**1.2 1-9 ALLEN STREET & 777-781 WARRIGAL ROAD, OAKLEIGH
USE AND DEVELOPMENT OF A RETIREMENT VILLAGE WITH FOOD AND DRINK
PREMISES (CAFÉ), SIGNAGE AND A REDUCTION OF CARPARKING
(TPA/53176)**

EXECUTIVE SUMMARY:

That Council resolves to issue a **Notice of Decision to Grant a Planning Permit (TPA/53176)** for the use and development of a retirement village with food and drink premises (café), alteration of access to a road in a Transport Zone 2, business identification signage and a reduction of car parking at 1-9 Allen Street & 777-781 Warrigal Road, Oakleigh subject to the following conditions:

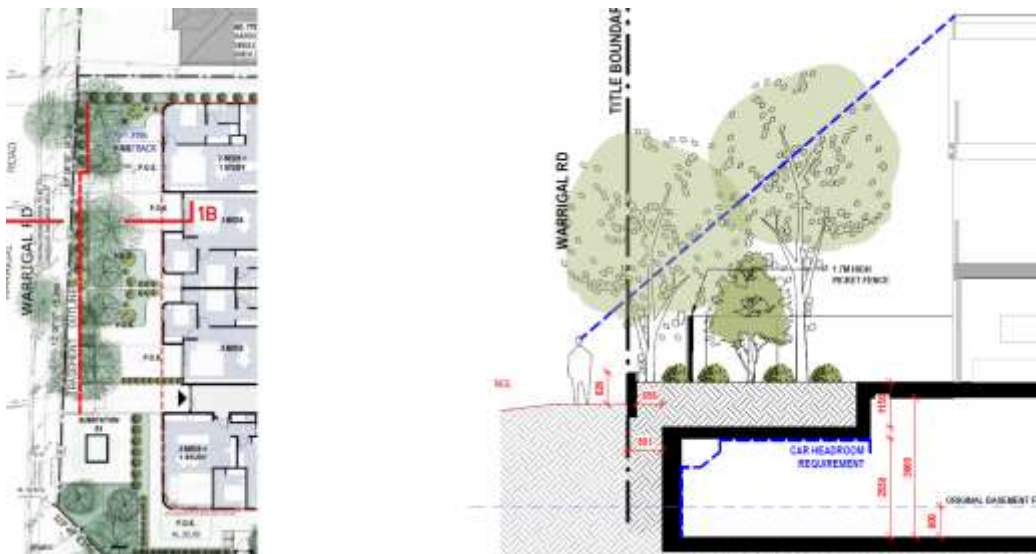
The proposed building has been designed to present as 3 storey to Warrigal Road; have a predominantly 3 storey presentation to the Scotchmans Creek and will generally be perceived as 3 storeys from the adjoining public open space. Part of the basement protrudes above ground level where the land falls significantly away where the building has a technical 4 storey height at this point.

The proposed setbacks on ground level provides sufficient space to provide meaningful landscaping and canopy trees which will assist in softening the

Eastern interface (Scotchmans Creek Trail)

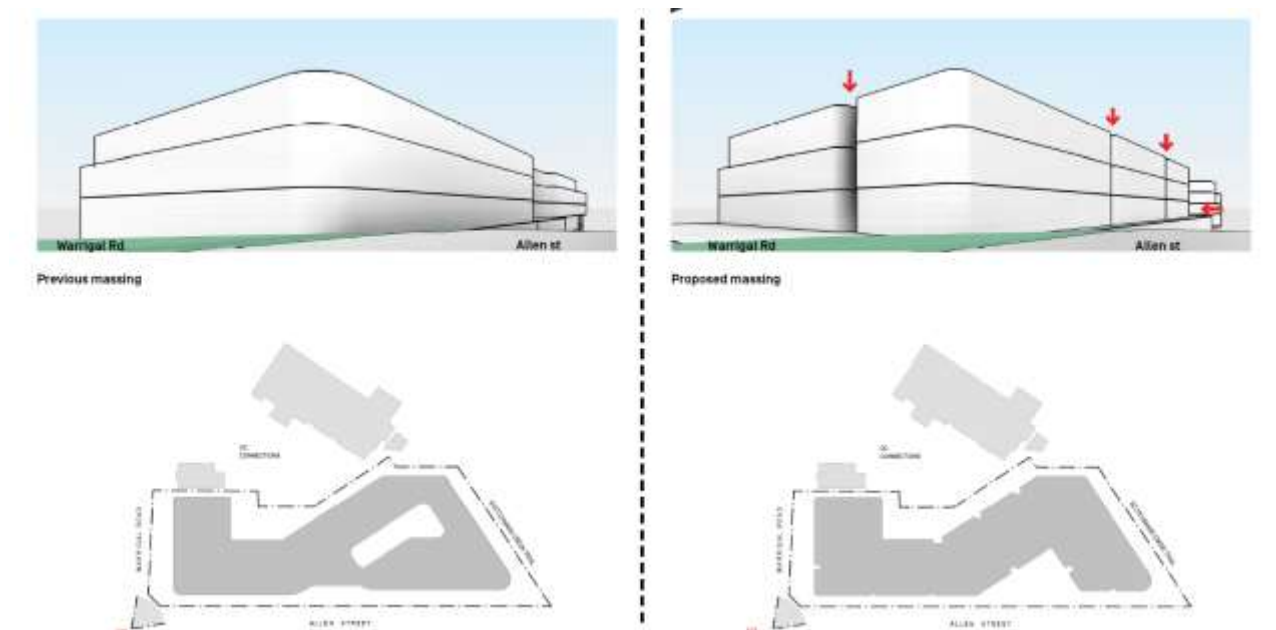
Given the proposed setbacks the development will be perceived as a 3 storey build when viewed from the east. The proposed lower ground level setback of 6 metres will provide adequate space for generous landscaping and canopy tree planting to achieve a dominant landscape outcome.

The proposed building height and setback is consistent with the approved development however the Tribunal in the previous application (discussed under the history section above) considered that it did not provide an adequate transition down the slope of the site towards the creek environs and that a greater level of stepping of the built form is required. A condition was required for the ground to provide a minimum setback of 7.5 metres and the first floor to be setback 9 metres from the eastern boundary, excluding the terrace balustrade.

The current proposal provides a lower ground level setback of 6 metres; and ground and first level setbacks of 6-8 metres. The majority of the ground and first floor still share the same setbacks as the lower ground level and does not provide sufficient transition down the slope towards the creek, and should be further setback from the eastern boundary, to improve the transitional interface to the east. Recommended permit conditions will require the ground and first levels to be setback a minimum of 7.5 and 9 metres from the eastern boundary, excluding terraces/balconies, to improve the transition interface to the creek. This will also achieve a consistent outcome with the previous Tribunal decision.

- a) The ground floor setback a minimum of 7.5 metres from the eastern boundary, excluding the terraces/balconies;
 - b) The first floor setback a minimum of 9 metres from the eastern boundary, excluding the terraces/balconies;
